SERVICE BULLETIN NO. 10

Relocation of Gascolator and Electric Fuel Pump when M-4-210 and

early M-4-210C are equipped with Dual Exhaust System 5230F.

96-10-05 MAULE AEROSPACE TECHNOLOGIES, INC.: Amendment 39-9610; Docket No. 95-CE-22-AD.

RELOCATE FUEL PUMP AND GASCOLATOR TO LEFT SIDE FIREWALL (VIEW LOOKING AFT):

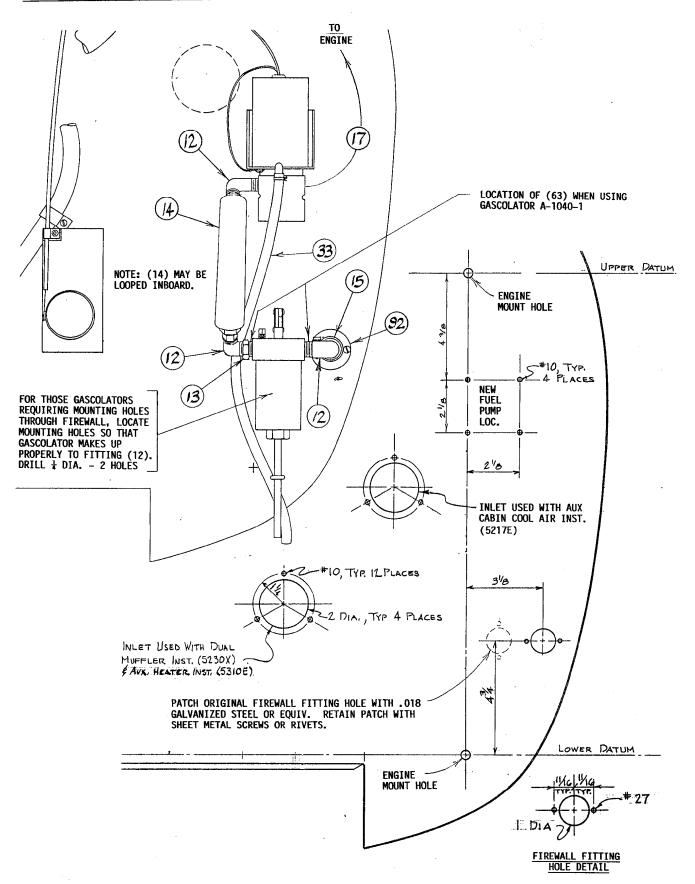
BACKGROUND: A Maule M-4-210 recently was retrofitted with the dual Exhaust System and upon completion of the installation the owner became aware of the close proximity of the left tailpipe to gascolator. Although we have never been notified of any problems resulting from this configuration, we nevertheless want to avoid any in the future.

ACTION TO BE TAKEN: Relocate Gascolator and Fuel Pump from its present location above the air egress to the left side location per this Service Bulletin.
